Comment Summary – November 21, 2024 (4th Submission)
Zoning By-law Amendment Application – WDD Main St. Inc.

RE: **NPG Comments
Main St
RE: Application for Zoning By-law Amendment & Draft Plan of Subdivision**

**Re: Zoning By-Law Amendment 4th Submission
11 Main Street (Morrison)
Puslinch, ON**

RE: Hydrogeological Review Comments – 4th Submission
WDD Main Street Inc. – 11 Main Street, Morriston (Puslinch), Ontario
Proposed Residential Subdivision
Zoning By-law Amendment / Draft Plan of Subdivision Application

File Number: 10779
Drawn By: SM
Planner: PT
Scale: 1:1500
CAD: 10040 Draft Plan D14 2024-09-03.dgn
Drawing Number: **D14**

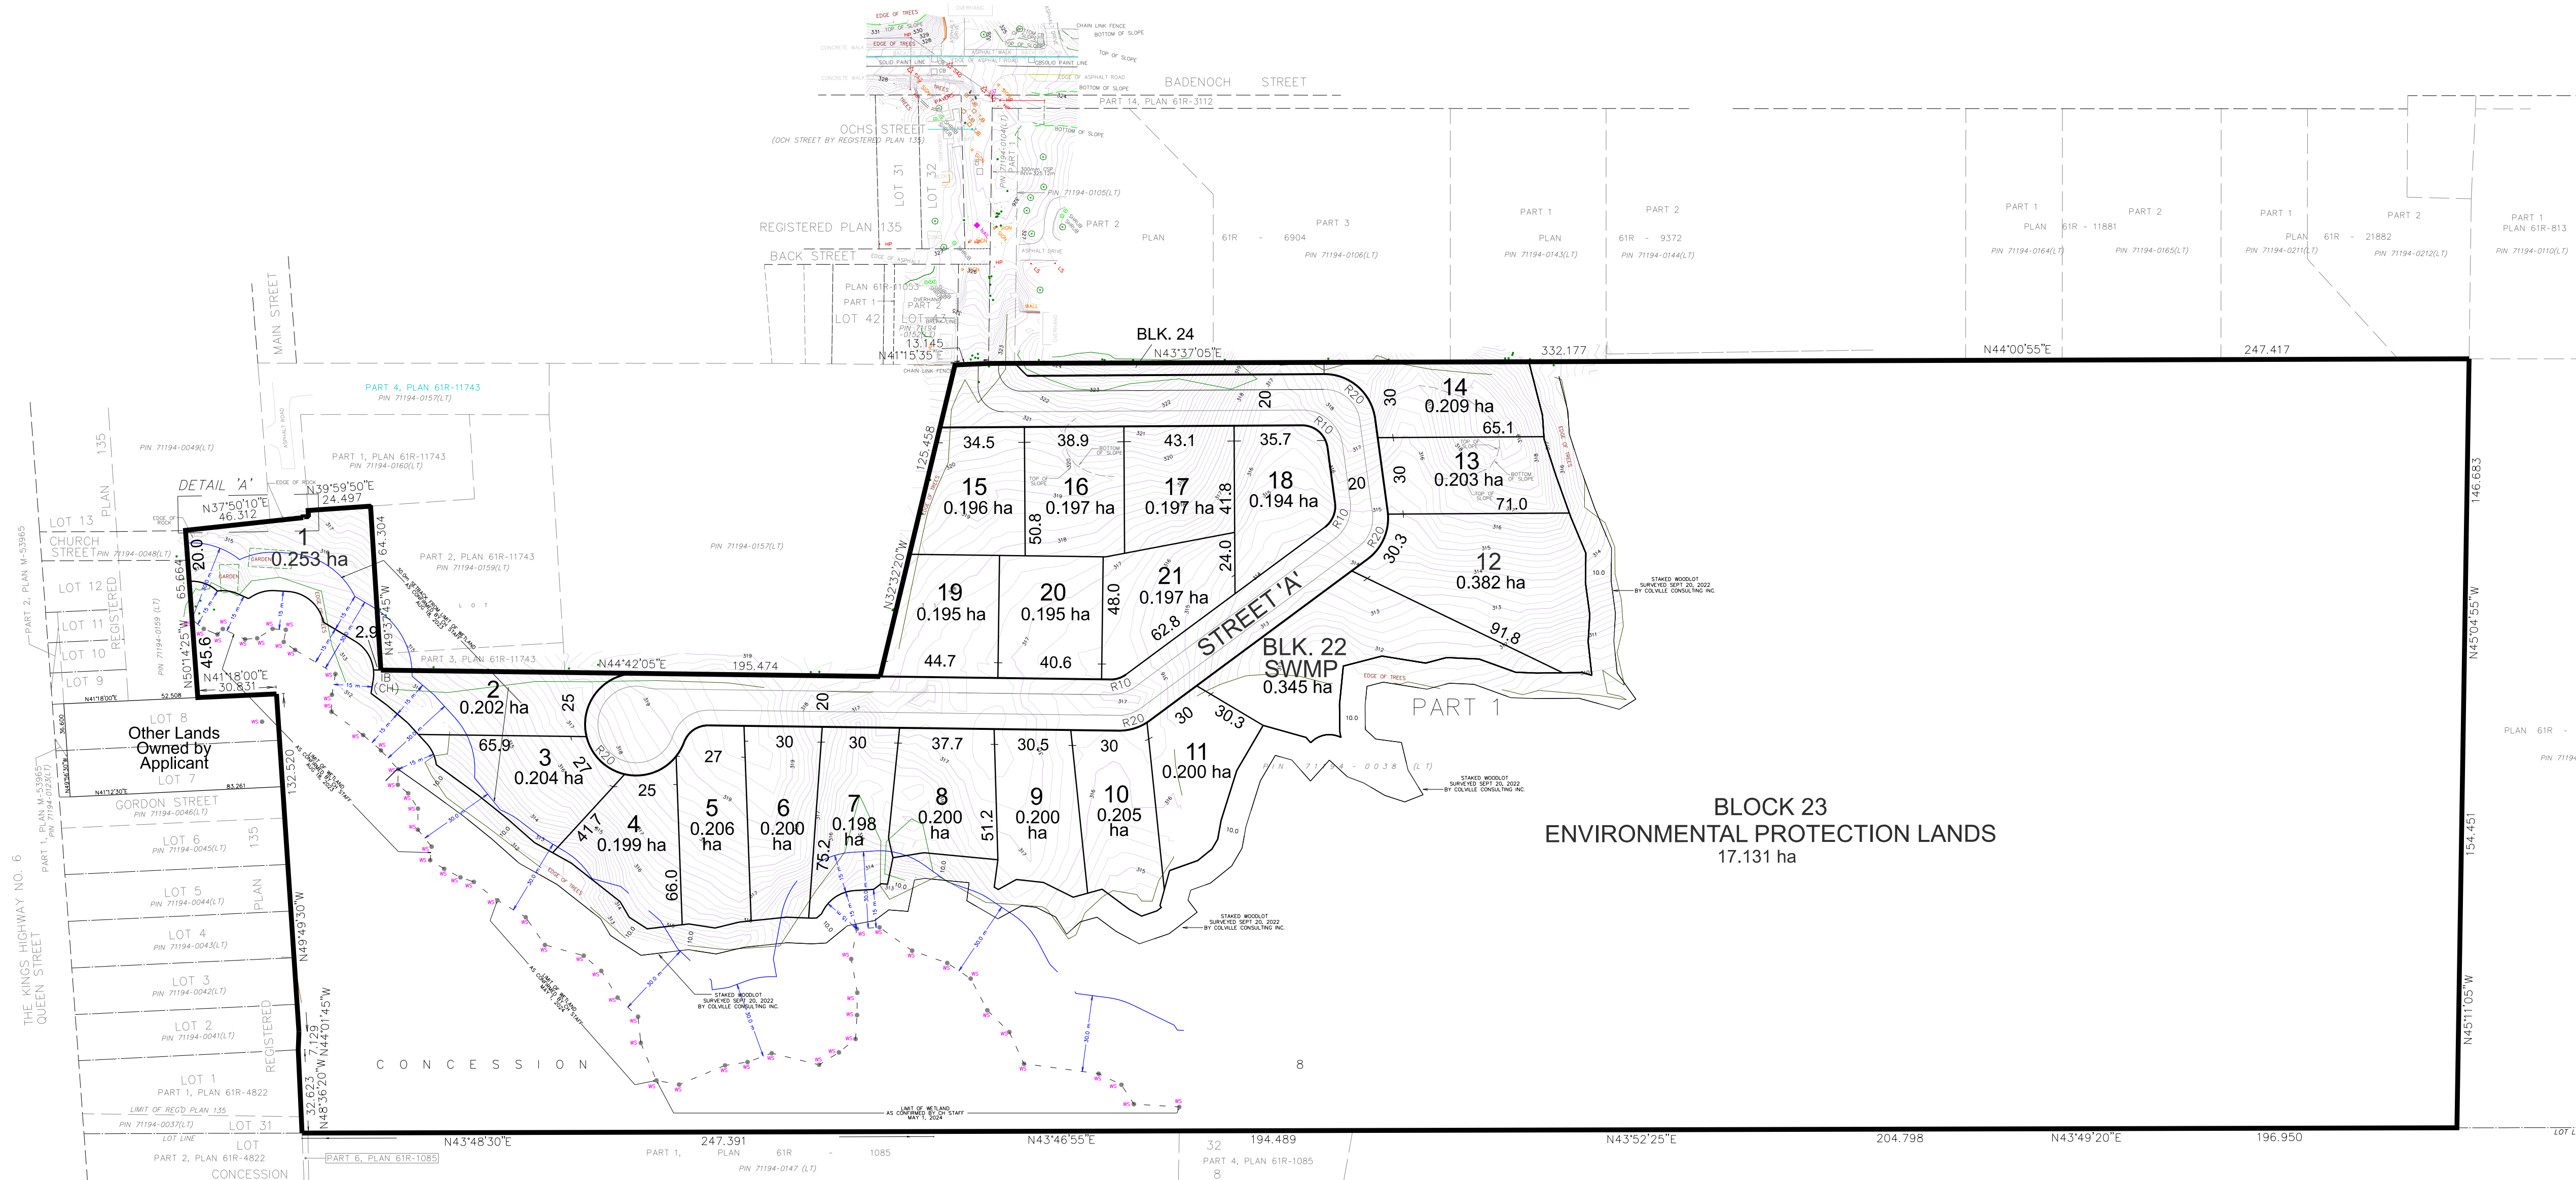
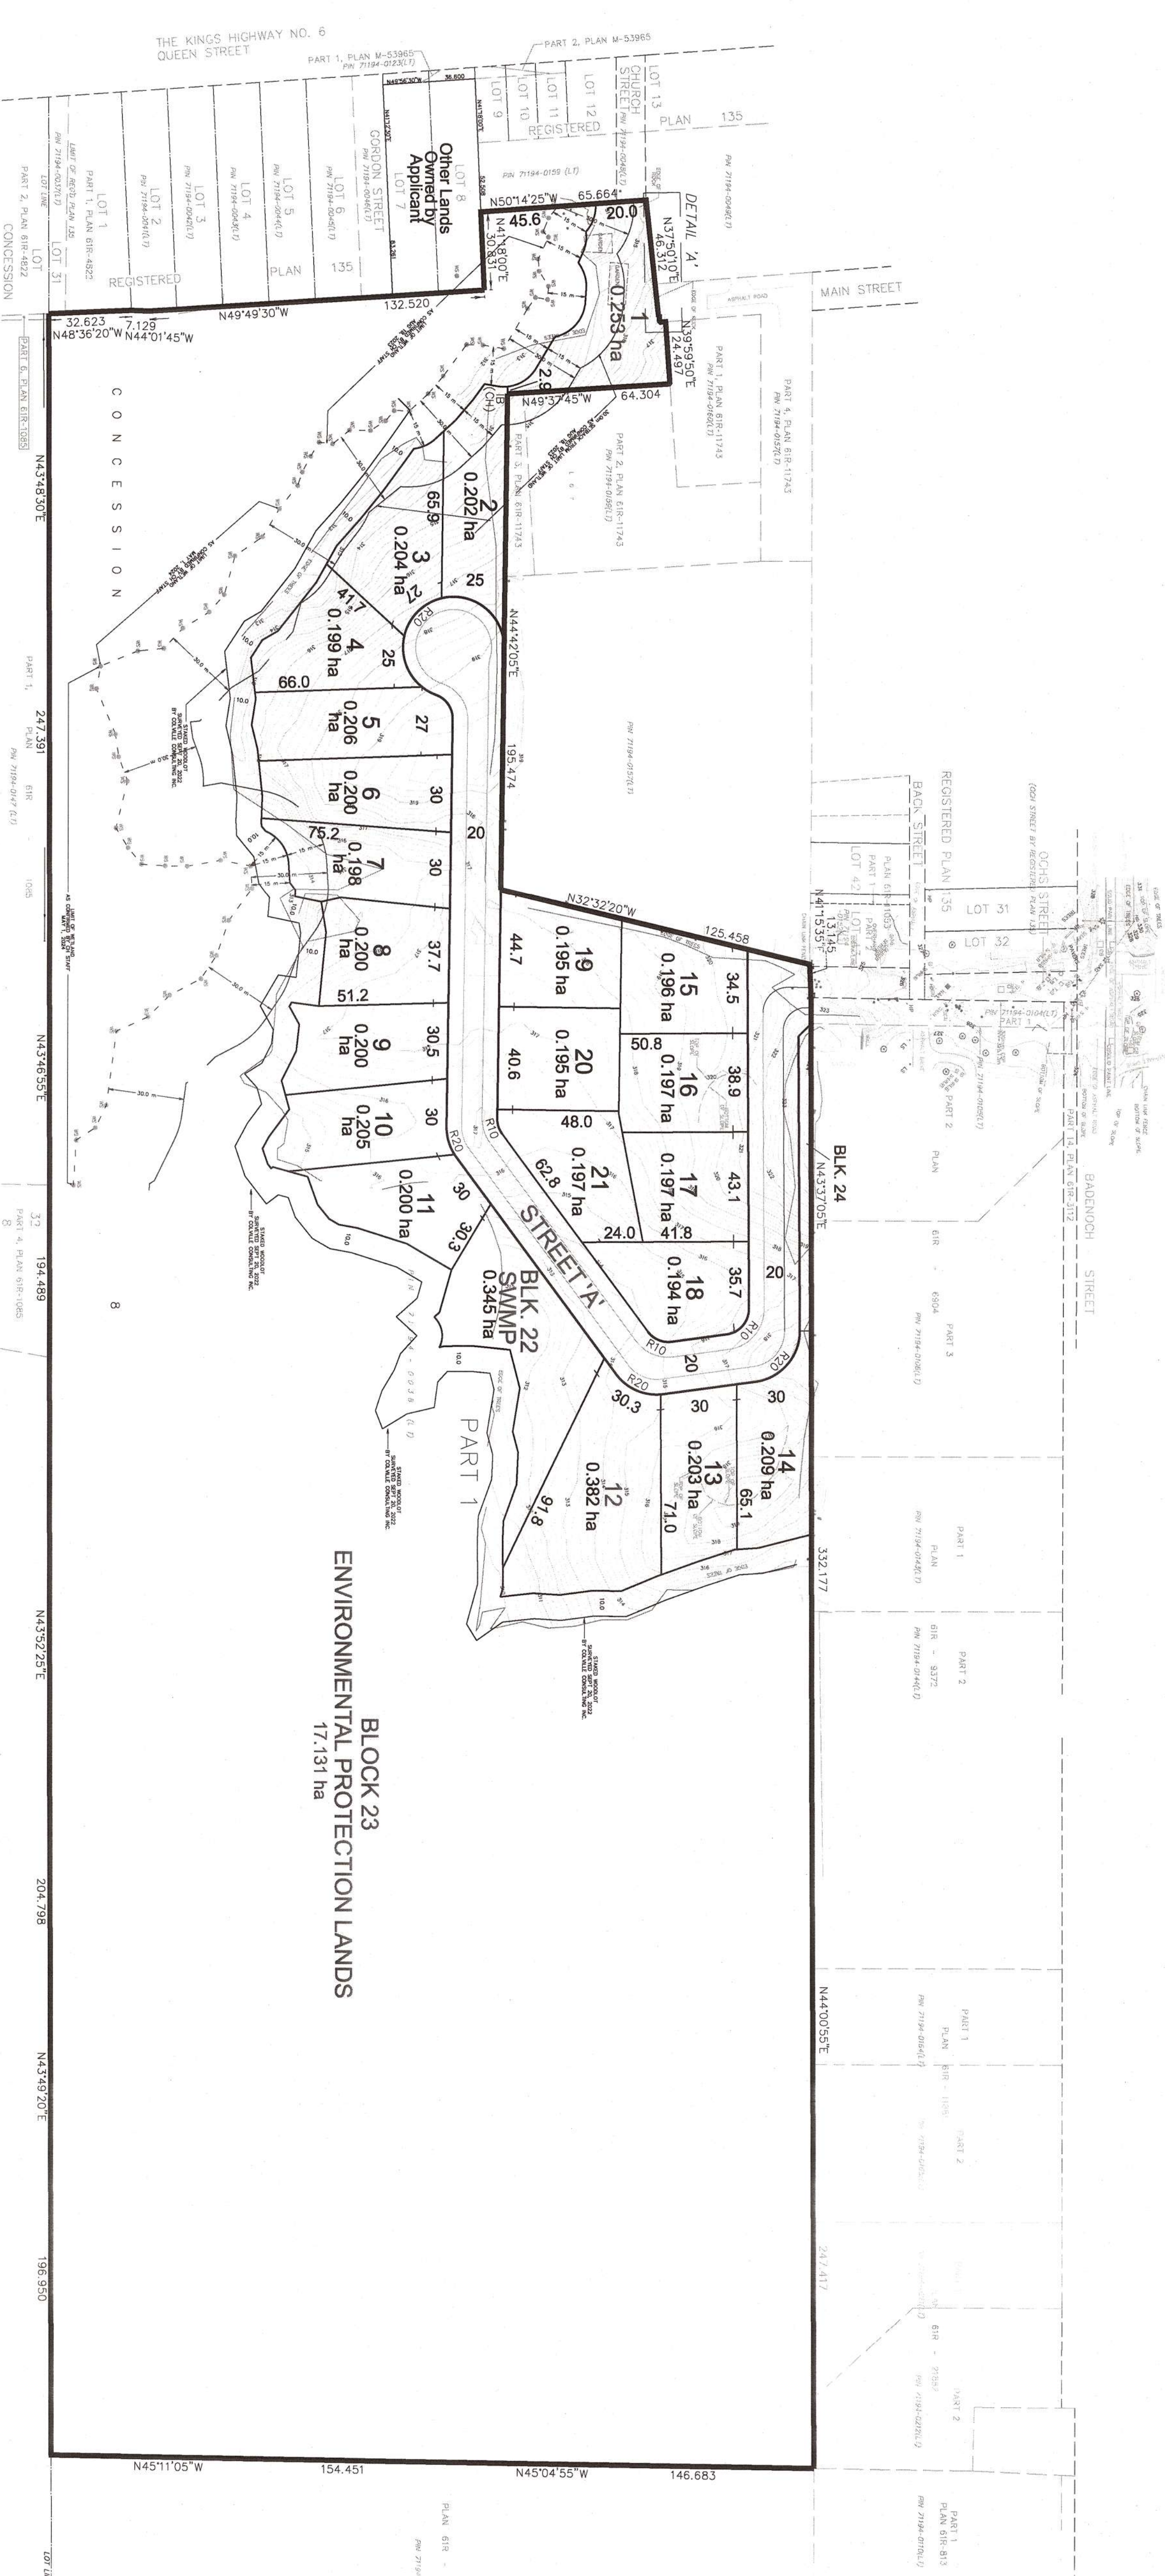
2. As previously noted, the Zoning By-law should address the exclusion of uses on the proposed stormwater management pond block. The revised Zoning By-law does not include any language addressing this matter.

3. The Schedule submitted by the Applicant should be revised to make the Environmental Protection Zone Overlay more visible since the overlay hatching is not legible.

4. Conservation Halton recommends their regulated area (wetland features plus the 30-m regulatory setback) be zoned appropriately and be conveyed to public ownership. The current Zoning By-law Amendment Application proposes to zone the wetland features and part of the 30-metre regulatory setback as Natural Environment Zone (NE) and the remaining part of the 30-metre regulatory setback as a site-specific Urban Residential Zone (UR(spXX)). The appropriate zones and their extent will need to be reviewed through the application process.

Drawn	M.I.M.	Design	M.I.M.	Project No.	2366-6537	
Check	B.W.	Check	B.W.	Scale	1:1000	
					Dwg.	FIG. 6

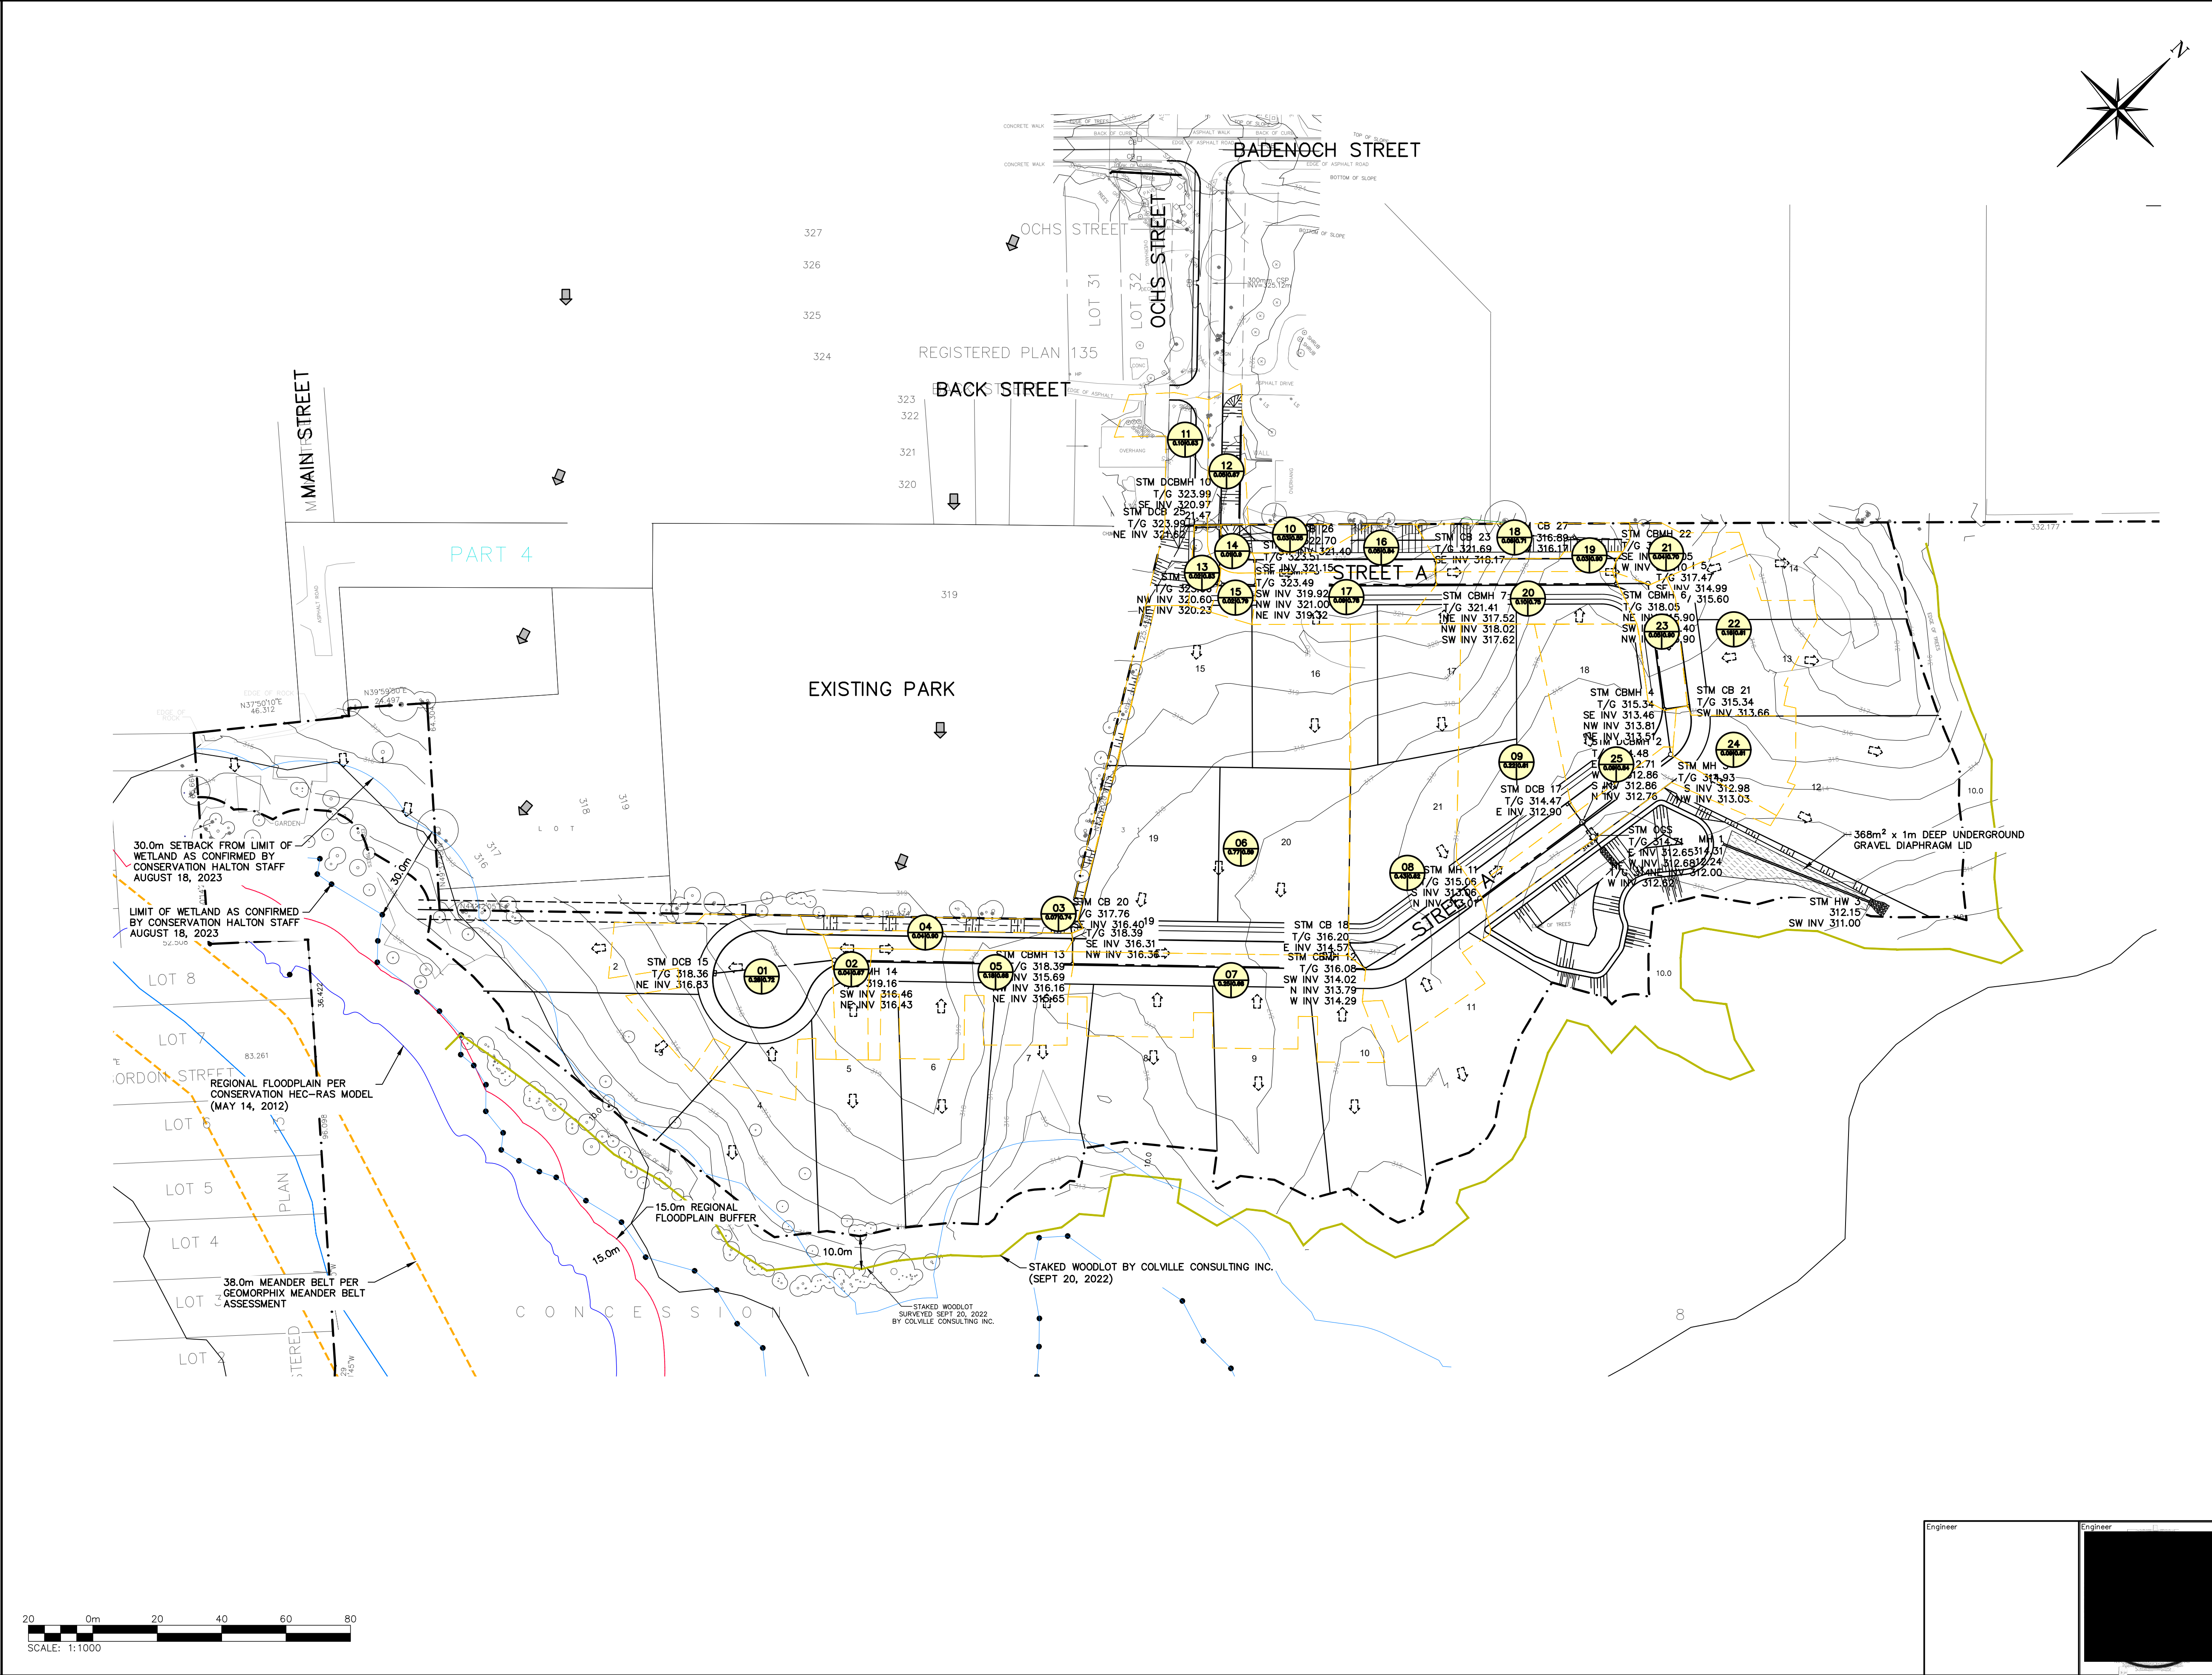
6.	Post-Development Drainage Plan	FSR	April 20, 2023	<p><u>GEI Comment (April 20, 2023)</u> Please label the imperviousness of the external areas on the Post-Development Plan for consistency.</p> <p><u>Crozier Response (January 2024)</u> The Post-development Drainage Plan has been revised to include the imperviousness of the external drainage catchments.</p> <p><u>GEI Comment (February 9, 2024)</u> Accepted, no further comment.</p>
